**CITY OF CANTON POLICE DEPARTMENT
151 ELIZABETH ST
CANTON, GA 30114**

FOLLOW-UP ROOF LEAK EVALUATION REPORT

**Re: Building Exterior Consulting Services
Roof Consulting Services
City of Canton Police Department
Canton, GA 30114
(W&A Project #: 24-01329-2)**

Diagram 1

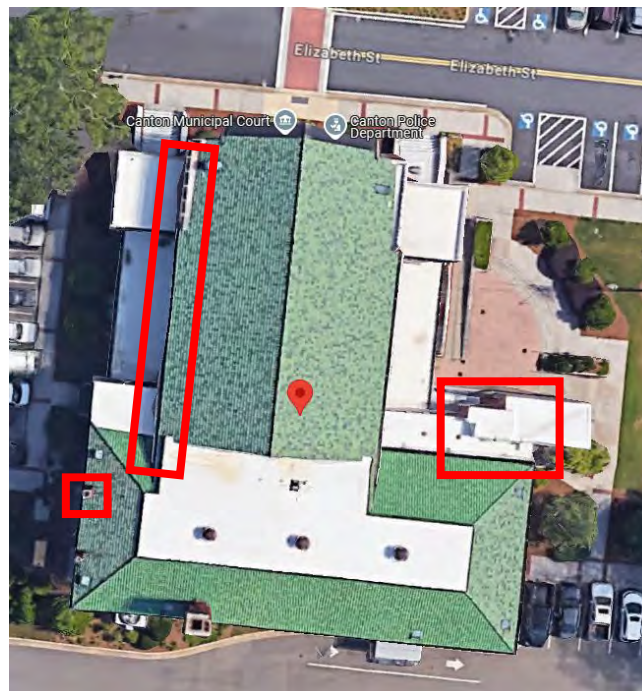
City of Canton personnel reported multiple leaks, which had grown in severity since our previous condition evaluation, general locations marked below in **Diagram 1**. The primary focus of the evaluation was to identify potential sources of leakage.

Photo 1

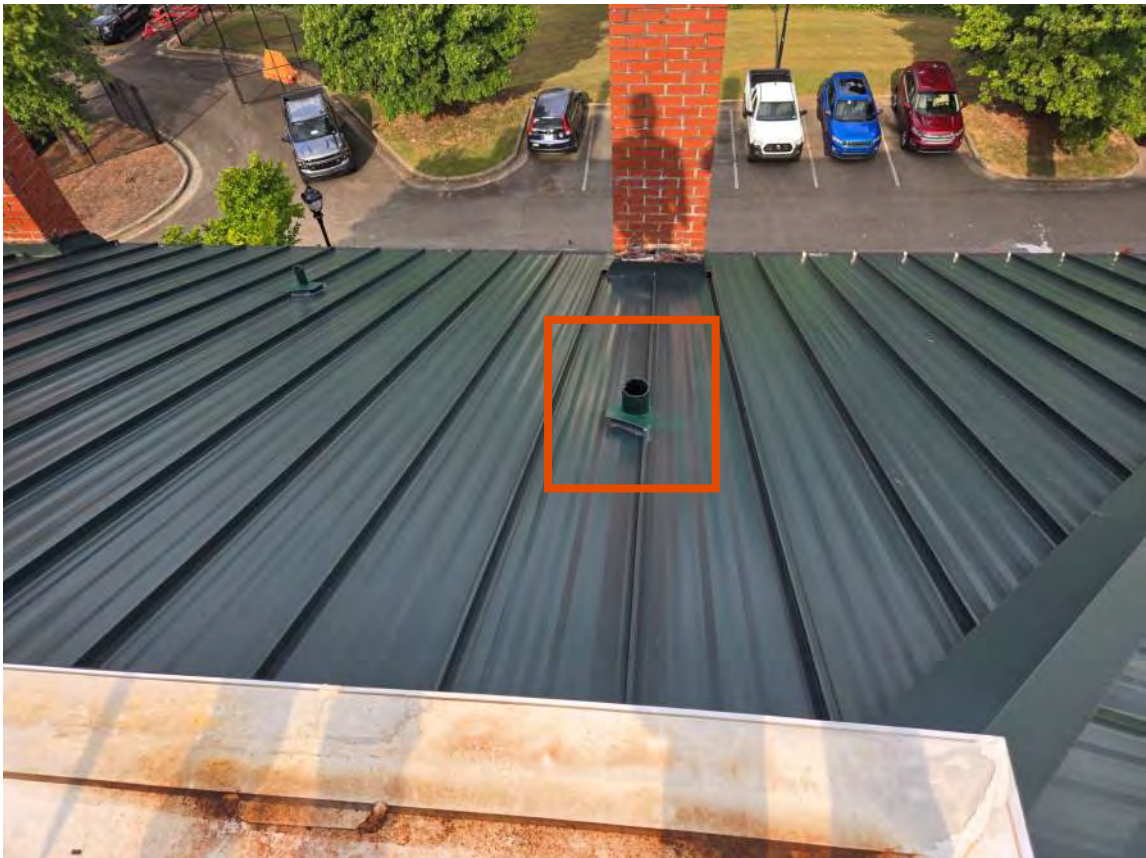
Photos 1 - 8 show that vent stack penetration flashing had been altered. Alterations were not in general accordance with published SMI details, as provided in our previous report. The sealant appeared to be clear silicone and not a professional grade sealant. These conditions are anticipated to be a source of leakage soon if left uncorrected.

Photo 25

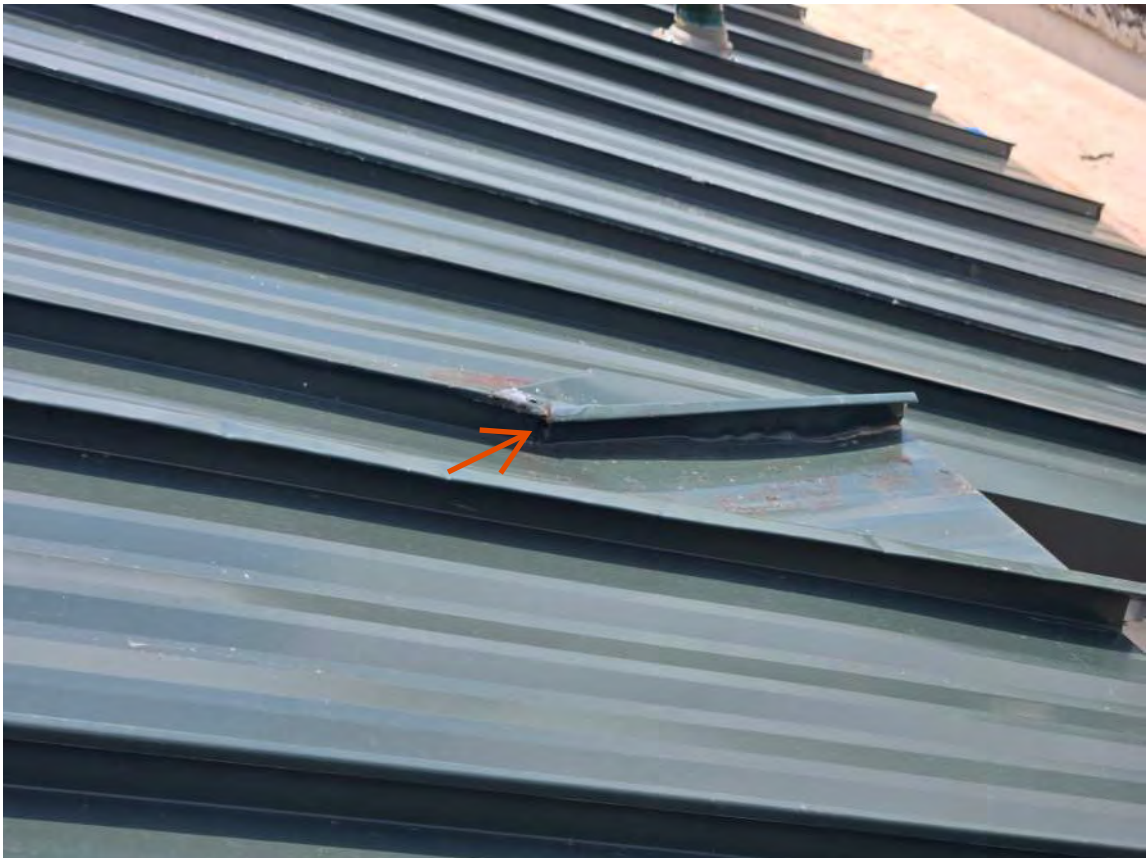
Photos 25 – 28 show a detail area within the reported area of corrective work. Panels were field bent to better follow the contour of the roof deck but the detailing of the bent panel and flashing with clear silicone sealant was improper and contained voids. The method of corrective work in this location does not appear to conform with what we would consider best practices.

Photo 31

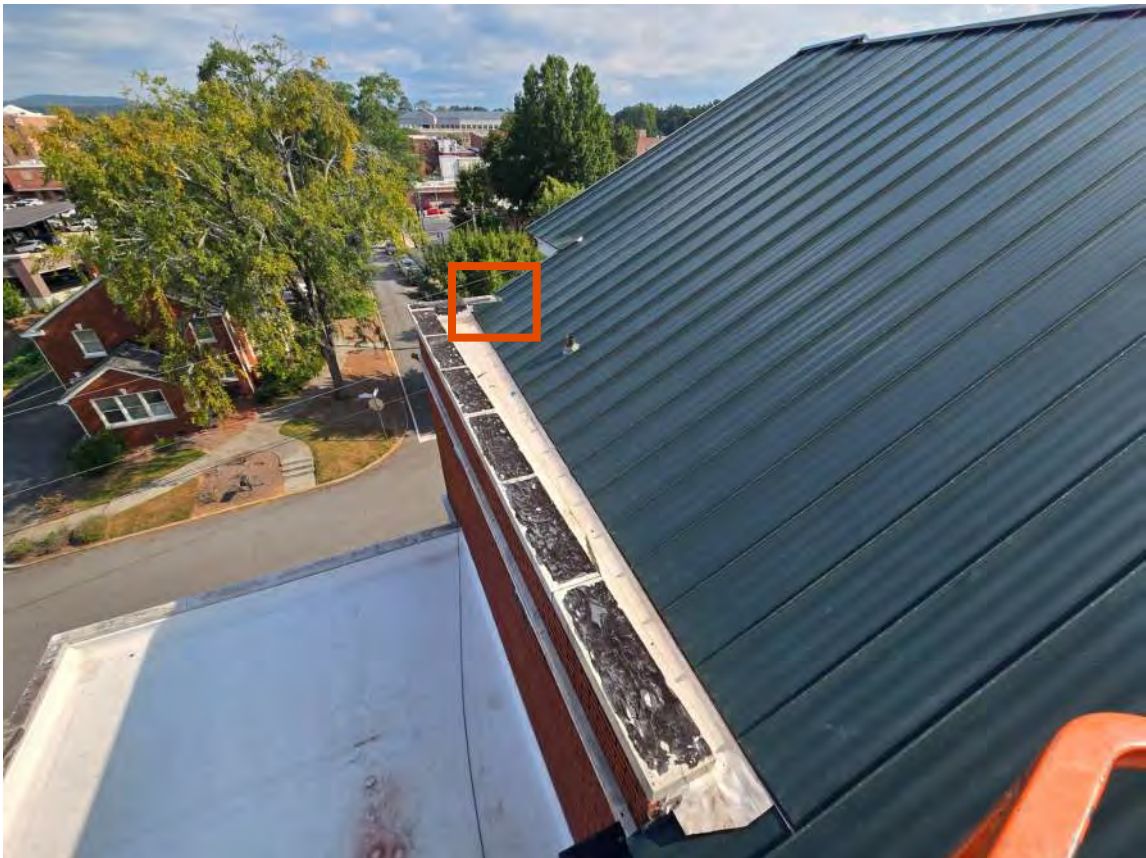
Photos 29 – 31 show an added penetration boot. The previously observed painted underlayment was left exposed and contained voids. The boot was detailed to the metal panel with clear silicone, indicating that butyl tape, as called for by SMI, was not likely underneath the penetration boot. The clear silicone was not well adhered to the panel.

Photo 46

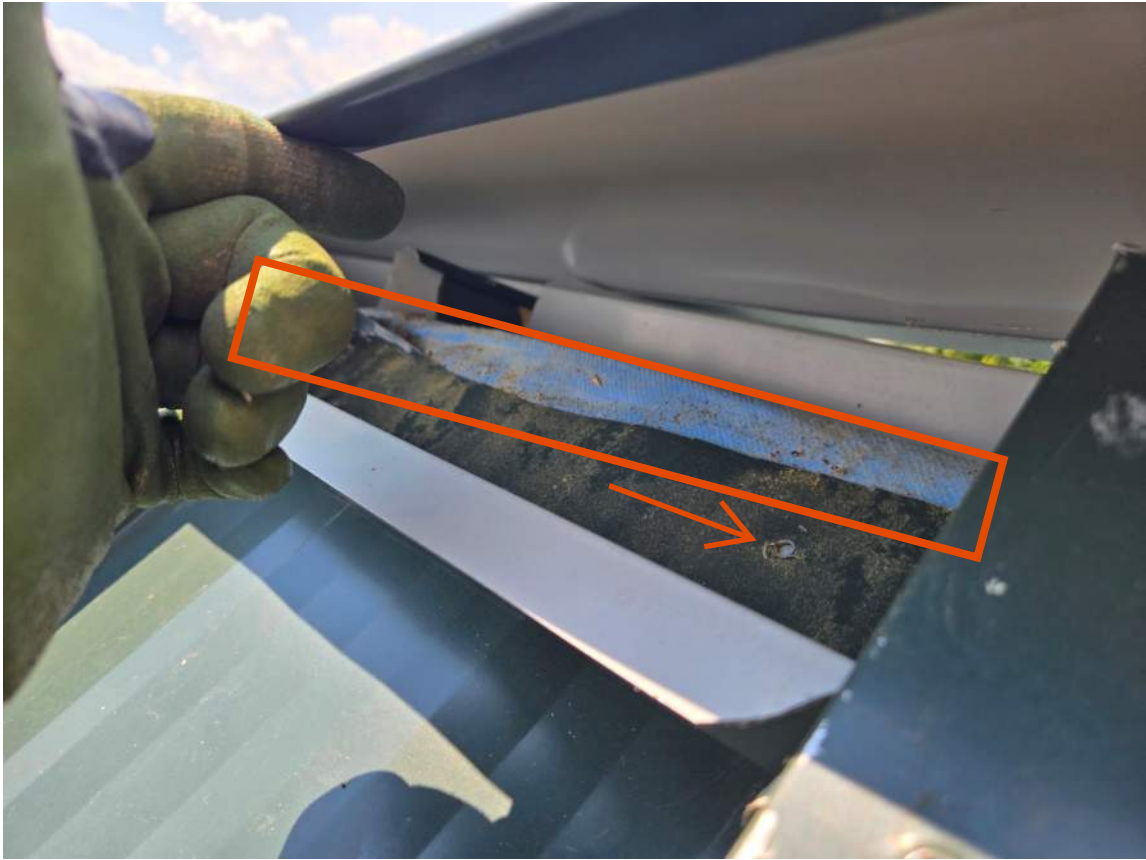
Photos 46 & 47 show that the panels did not contain boxed ends at the ridge, under the ridge cap, which was not in accordance with SMI required detailing.

Photo 73

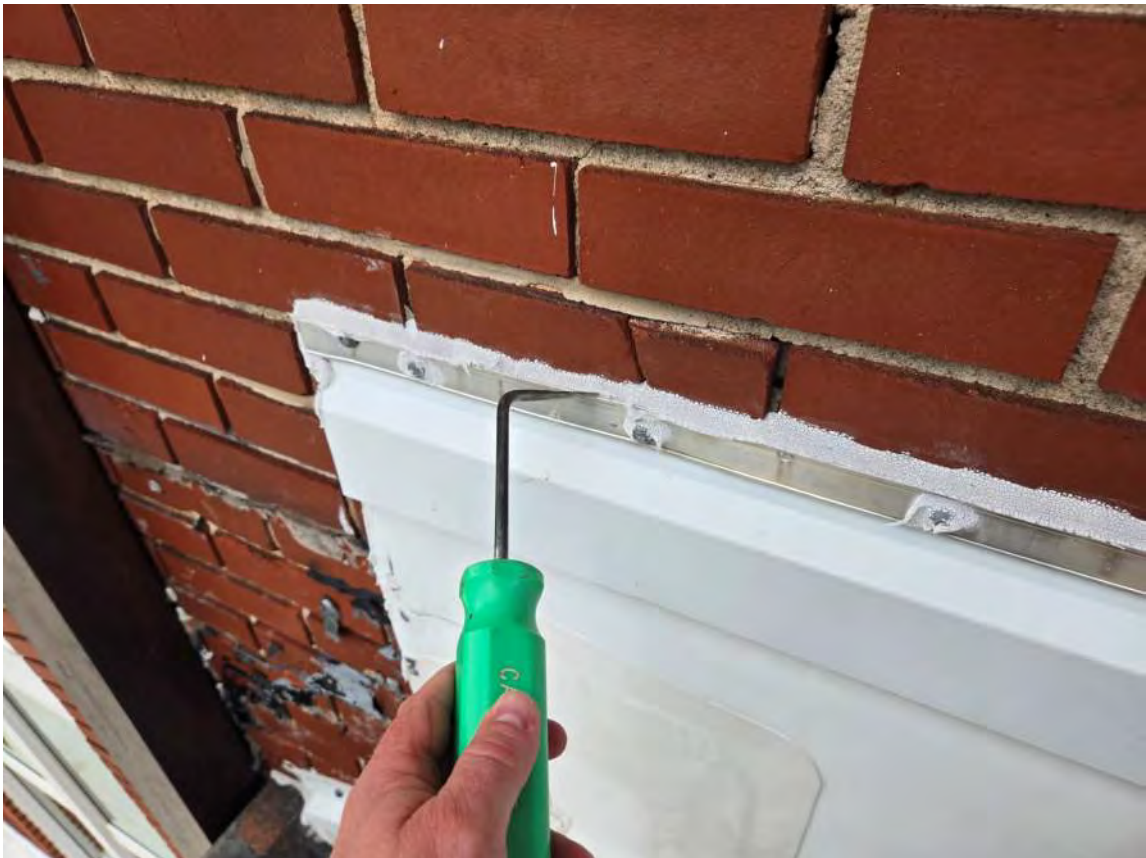
Photos 71 – 73 show masonry distress above the roof flashing. This masonry distress would likely allow bulk water to enter the wall system and bypass the roof flashing.

- Tuck point areas of wall with missing/degraded mortar above roofing terminations and within areas of exterior wall above leakage. See **Photos 71 – 73, 92, 93, 123, 124, 126 – 128** as examples.
- Repair areas of cracked masonry/masonry distress. See **Photos 95, 101** as examples.
- At rising masonry walls, consider the application of a clear silicone coating after the tuck pointing has been completed. Clear silicone coatings, such as GE Optic, allow the wall system to continue to function as originally intended while limiting bulk water entry into the wall system.
- Remediate cementitious panels at gable ends of roof. See **Photos 52 – 54** for example areas.
- Re-solder copper gutters

Photo 75

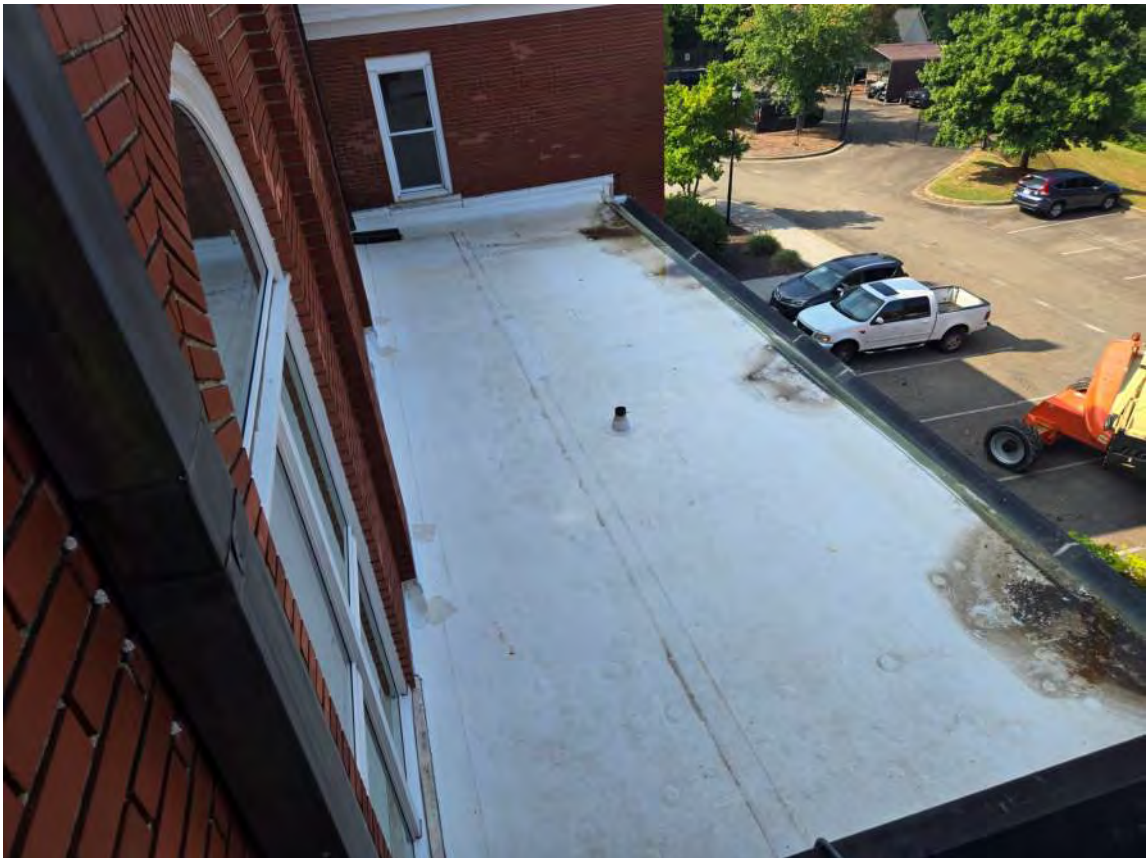
Photos 74 & 75 show that the new roof flashing membrane was not well terminated over the top of the existing roof flashing at the rising wall. This would likely allow water to enter the roof assembly and leak into the building. Existing sealants had not been replaced and were past their service lives. The degraded sealant would also likely allow water to bypass the surface mounted counter flashing.

- Remove the current counter flashing and associated sealants from the assembly entirely.
- Perform edge termination detail similar to Elevate Detail TPM-T-06 (**Attachment C**). Existing counter flashing may be able to be reused.

Photo 91

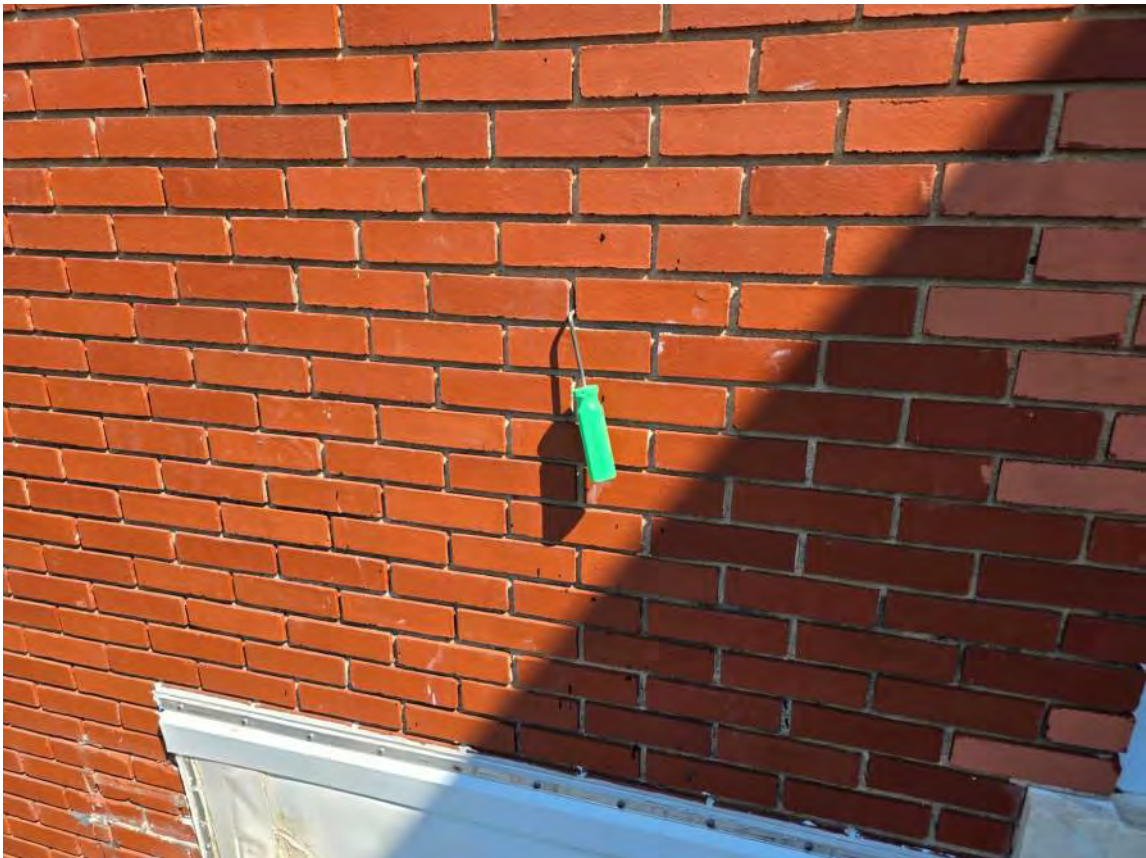
Photos 81 – 91 show that the roof flashing from the older roof was still in place and that termination sealants had failed in many areas. The new roof flashing was not adhered to the wall and was not properly terminated. The roof flashing could be pulled out from under the older roof counter flashing and when it was, water was observed beneath the flashing. We removed roofing membrane and discovered that roofing coverboard and insulation in the area was wet. We also observed that the old roof flashing had been left in place.

- Perform moisture survey to locate areas of wet roofing materials, as present, and remove and replace those materials.
- At stone windowsills, remove existing coatings, sealants, etc down to bare stone/metal and install a liquid flashing system by Elevate. Lap liquid flashing onto the newly applied termination detailing sealant to provide continuity of the system. See **Photos 81, 88 & 89** for example locations.

Photo 108

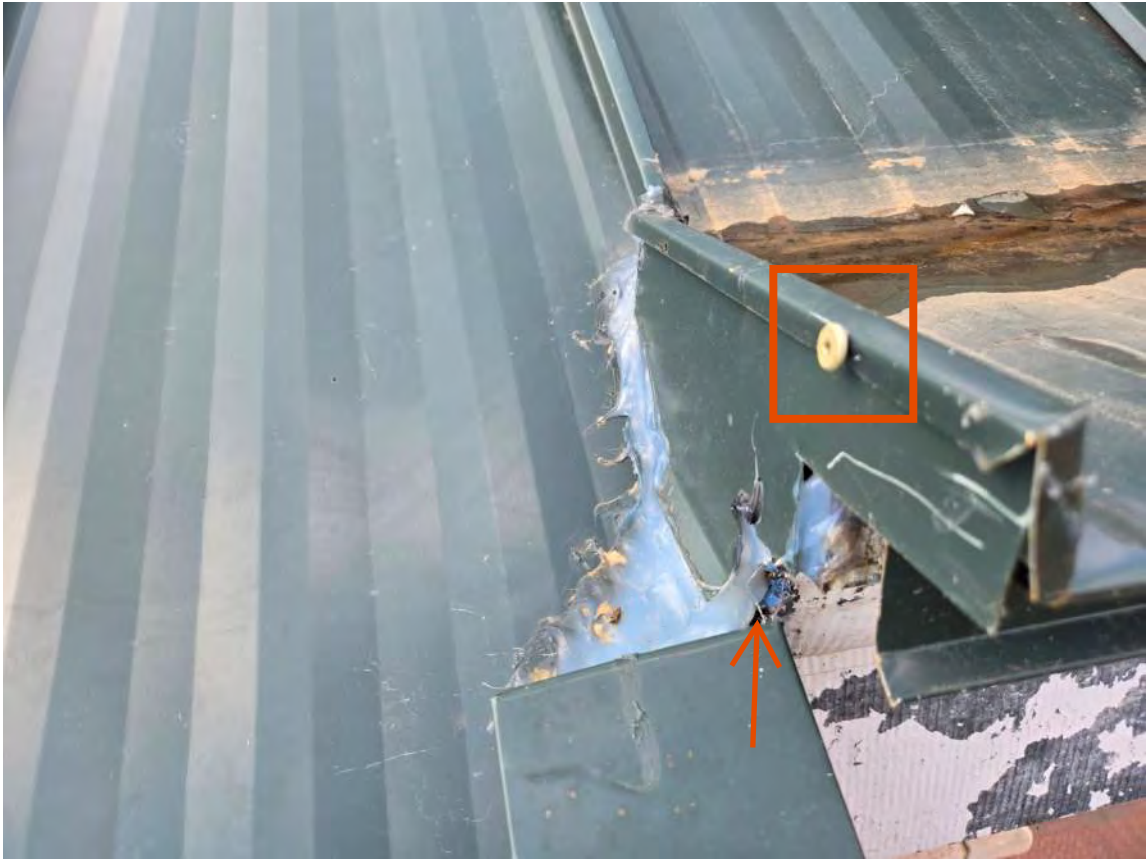
Photos 108 – 119 show similar level of detailing to what was observed on the west side of the roof. Voids had been left at transition areas and changes of plane. Sealant voids were present in new and older sealants. Flashings were not well secured to the roof.

REPLACED DETAILS
UT-T-06 & PVC-T-06

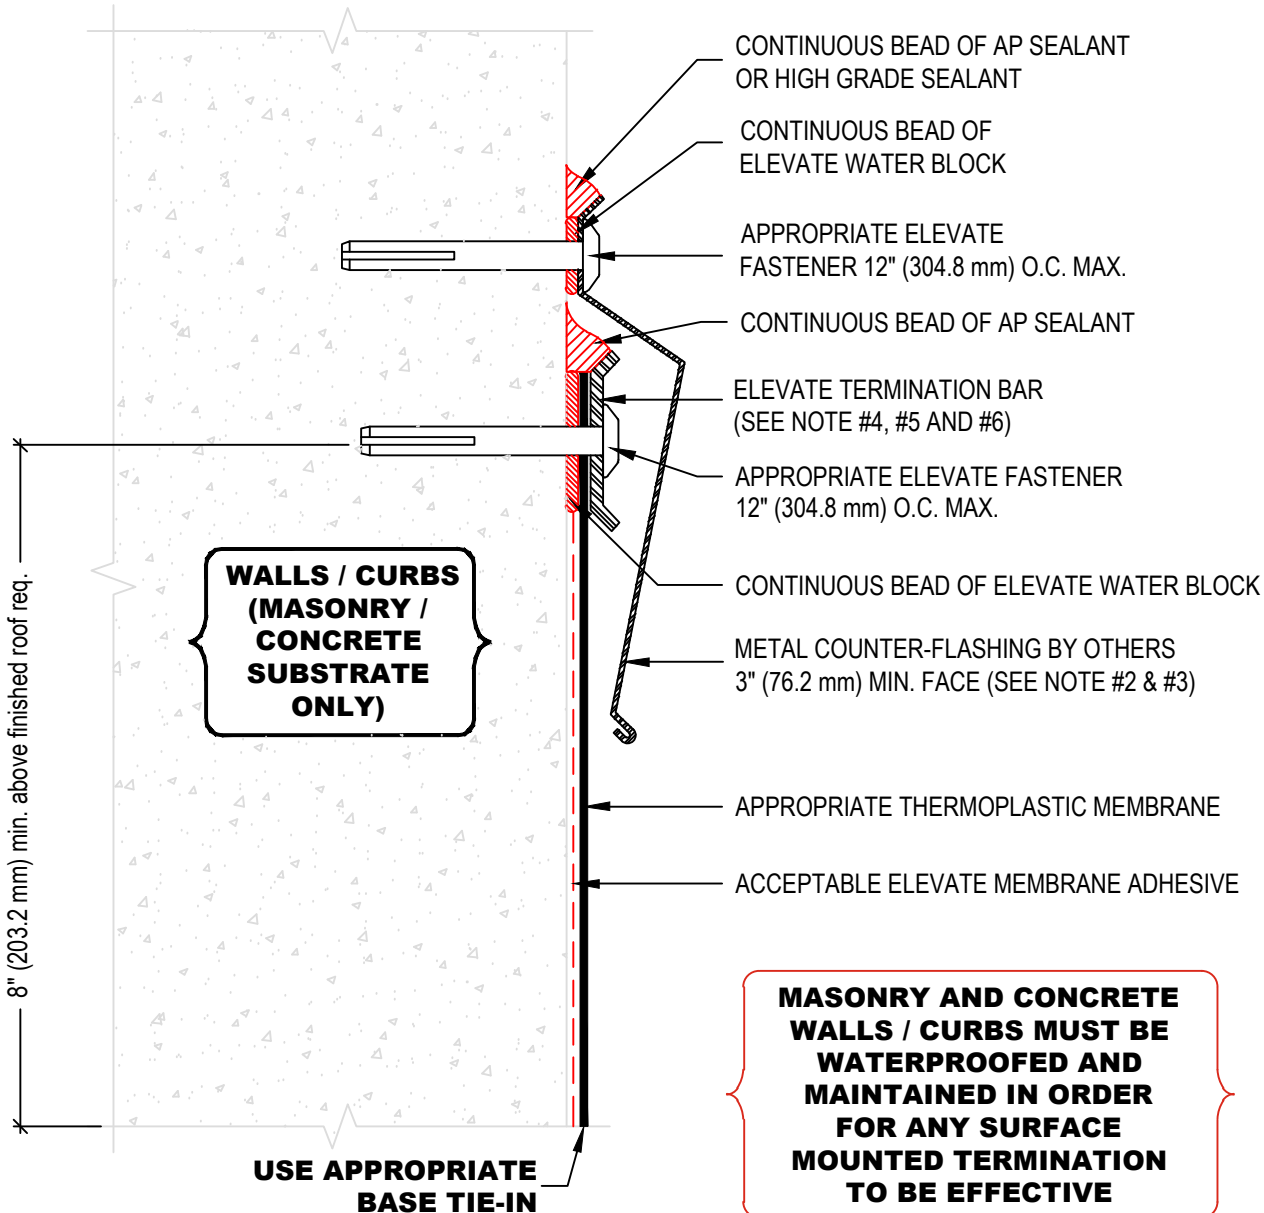
The primary source of leakage currently, however, appears to be deficiencies in the single ply roofing vertical flashings and potential material degradation above those vertical flashings, in Roof Areas 4, 5, 6 and 7. The current vertical flashing detailing relies on the integrity of the rising wall mortar, counter flashing and counter flashing sealant to keep water out of the building. The counter flashing for the current roof was left over from the previous roof. This is normally an acceptable practice, if the counter flashing is removed to allow for proper membrane termination onto the vertical wall. This did not happen. With degraded mortar joints above the counter flashing and degraded sealants at the counter flashing water has multiple access points to bypass the roof flashings and enter the building.
